**GS #103-281
ALEXANDER CENTER RENOVATIONS - PHASE II (Building 'A' Buildout)
JACKSON STATE UNIVERSITY
JACKSON, MISSISSIPPI**

Addendum No. 1

May 23, 2016

This addendum forms a part of the contract documents and modifies the original plans and specifications dated February 26, 2016.

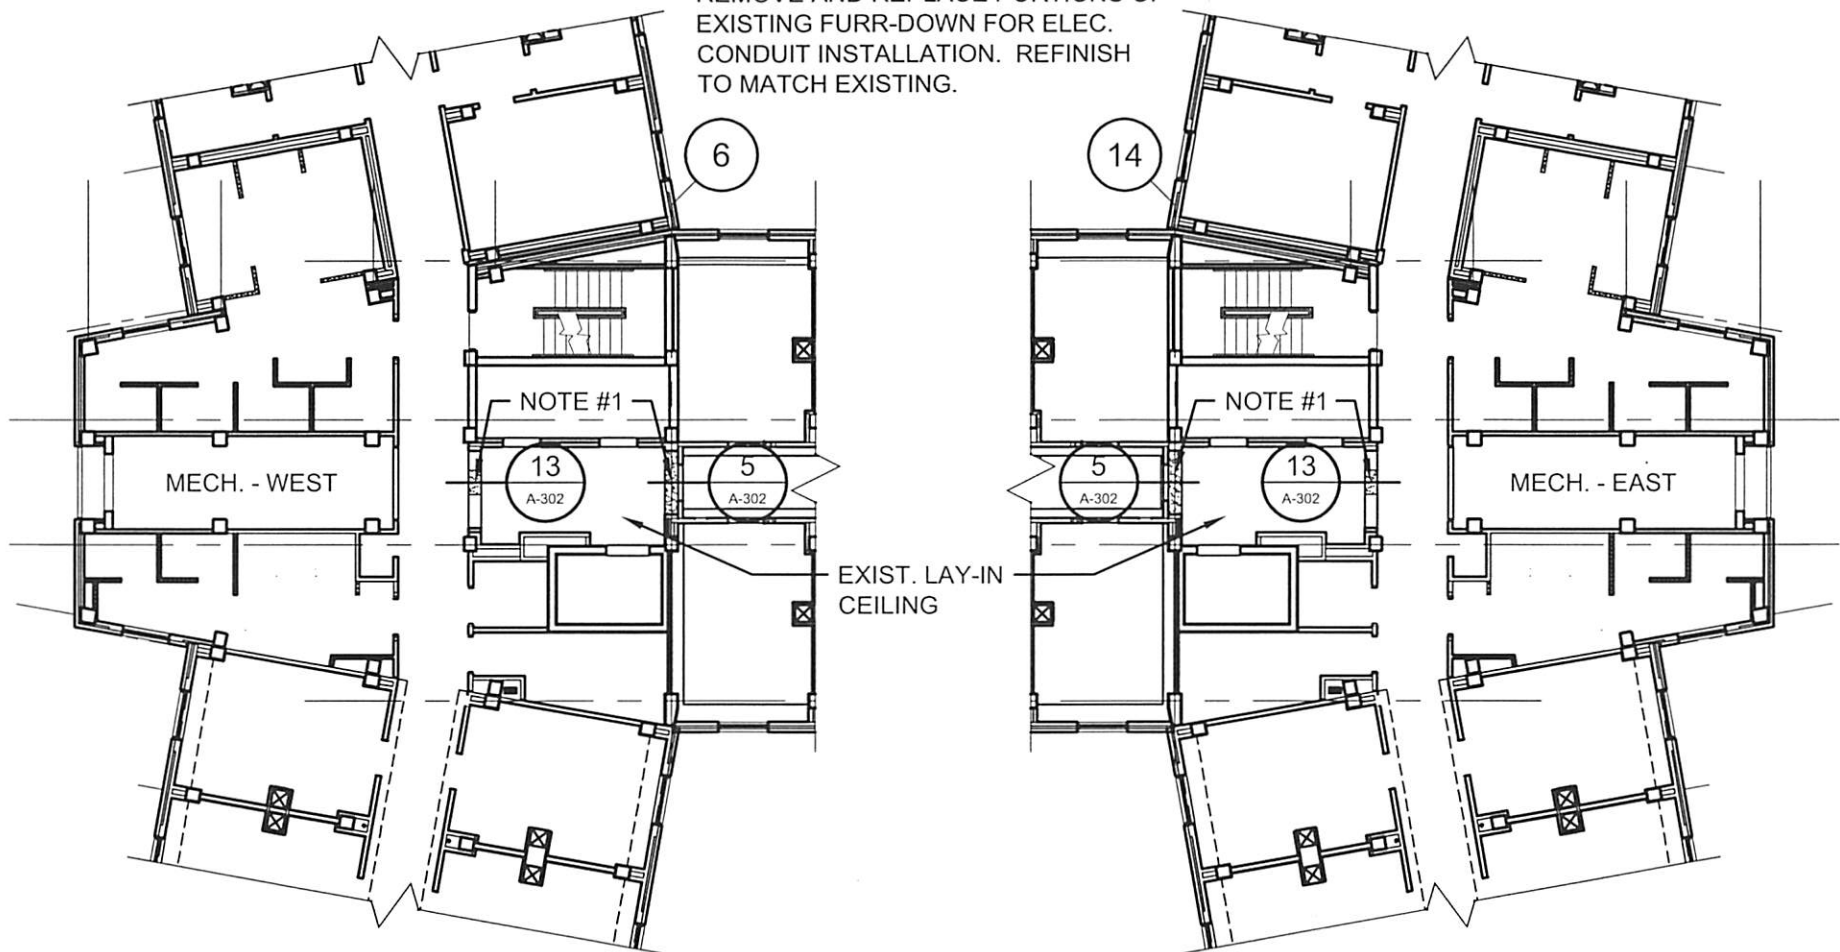
Replace: Sheet No. 23 with the attached sheet indicating an allowance amount of \$45,000.00 for HVAC controls in Paragraph 2.01.A.

- A. Include in the Bid, for inclusion in the Contract Sum, the amount of \$ 45,000.00 for purchase of
HVAC Controls
(Refer to Section 15900, Controls and Instrumentation)
- B. Include in the Bid, for inclusion in the Contract Sum, the amount of \$ _____ for purchase of

AS-01

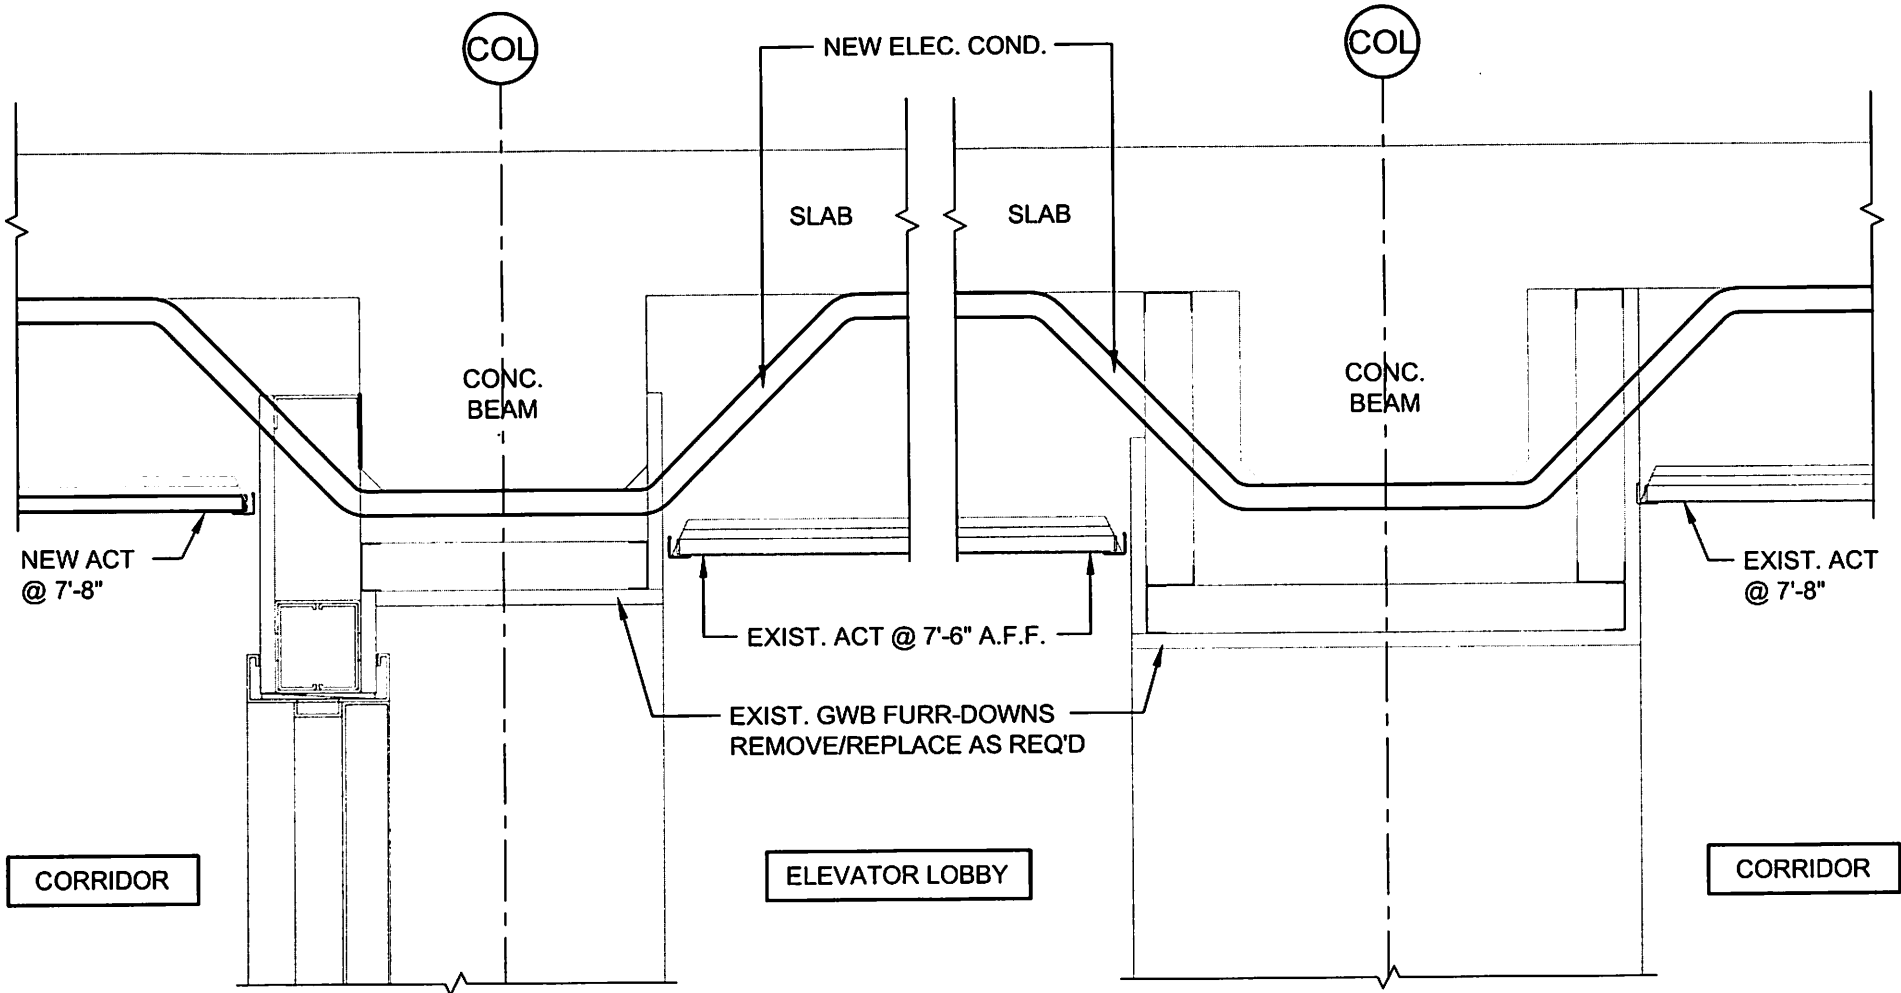
Add: The two attached supplemental drawings to identify routing of conduits from the existing electrical panels in the east and west mechanical rooms and the work required to achieve this routing to the middle wing 'A'.

REMOVE AND REPLACE PORTIONS OF
EXISTING FURR-DOWN FOR ELEC.
CONDUIT INSTALLATION. REFINISH
TO MATCH EXISTING.
